AMENDMENT NO. 3 (02/2019)

AIS-099

**Approval of Vehicles with regards to the Protection of the Occupants
in the event of a Lateral Collision**

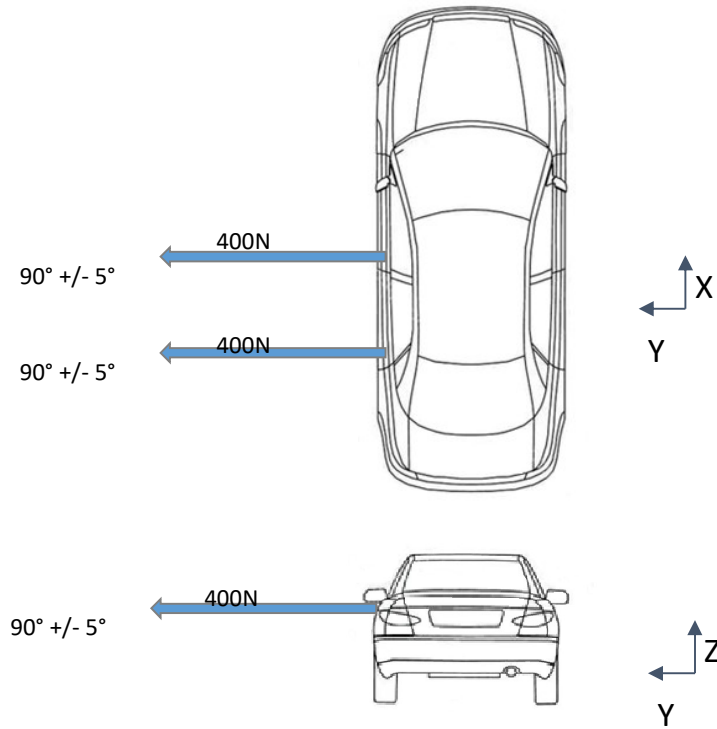
2. Page No. 5/92, Paragraph 5.3.1., amend to read:

"5.3.1. No door shall open during the test.

- (a) If it is clearly visible, that the door lock is latched; or
- (b) If the door does not open under a static tractive force of at least 400 N in the y-direction applied to the door, according to the Figure below, as close as possible to the window sill and to the edge of the door opposite to the hinged side, except to the door handle itself.
